# Access Compliance Report

## Public Rights-of-Way

Intersection ID: 26208	Main Street: BALLANTRAE VILLAGE DR	Cross Street: ELM LN	Location: SE
ADA ID: 27E1C68FF3A0	Ramp Type: MedianPerp	Initial Pass/Fail: Fail	Overall Compliance: No
Severity Score: 33.75			
Codes/Mitigation Info/Possible Solution		Field Measurements/Component Compliance

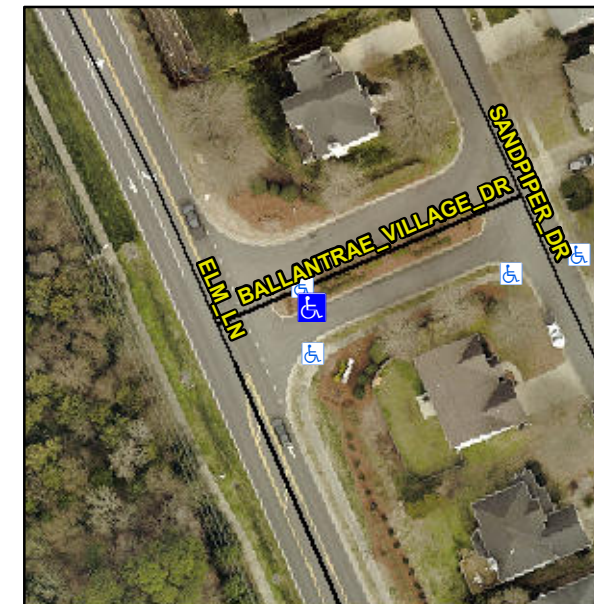
**Not Found, R304.5.1, R304.5.3**

Compliance	Description	Data	Compliance	Description	Data
N/A	Ramp Length (in)	69.0	Yes	Ramp Slope (%)	7.6
No	Ramp Width (in)	46.0	No	Ramp XSlope (%)	7.1
N/A	Flare Type LT	N/A	N/A	Flare Type RT	N/A
N/A	Flare Slope LT (%)	N/A	N/A	Flare Slope RT (%)	N/A
N/A	Flare Traversable LT?	N/A	N/A	Flare Traversable RT?	N/A
N/A	Landing Length (in)	N/A	N/A	DWS Provided?	N/A
N/A	Landing Width (in)	N/A	N/A	DWS Contrast?	N/A
N/A	Landing Slope (%)	N/A	N/A	DWS Length (in)	N/A
N/A	Landing X Slope (%)	N/A	N/A	DWS Full Width?	N/A
N/A	Landing Curb? (Y/N)	N/A	N/A	DWS Offset (in)	N/A
N/A	Shared Landing?	N/A			
N/A	Gutter Ponding?	N/A	N/A	Gutter Slope (%)	N/A
N/A	Gutter Lip Ht (in)	N/A	N/A	Gutter X Slope (%)	N/A
N/A	Painted X Walk1?	No	N/A	Painted X Walk2?	N/A
	X Walk 1 Direction	To S		X Walk 2 Direction	N/A
N/A	X Walk 1 Width (in)	N/A	N/A	X Walk 2 Width (in)	N/A
	X Walk 1 Slope (%)	1.9		X Walk 2 Slope (%)	N/A
	X Walk 1 X Slope (%)	6.6		X Walk 2 X Slope (%)	N/A

**Remove & Replace Entire Ramp.**
